**Mountjoy Modular** Sheet: /

Title: Quilter Components

Date: 2023-03-22 Size: A4 Rev: v1.0 KiCad E.D.A. kicad (6.0.11) Id: 1/5

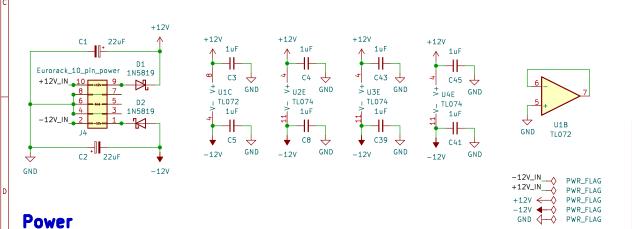
Potential V2 fixes: Potential V2 Tixes:
Mixed audio too loud — R6 try 4.7k in place of 10k (or variable resistor)
Mixed audio has DC offset — use blocking caps on Audio\_Out?
Resonance cannot reach maximum on all variants
— reduce Q Control resistor from 27k to 24-25k (R27, R40, R53, R66)
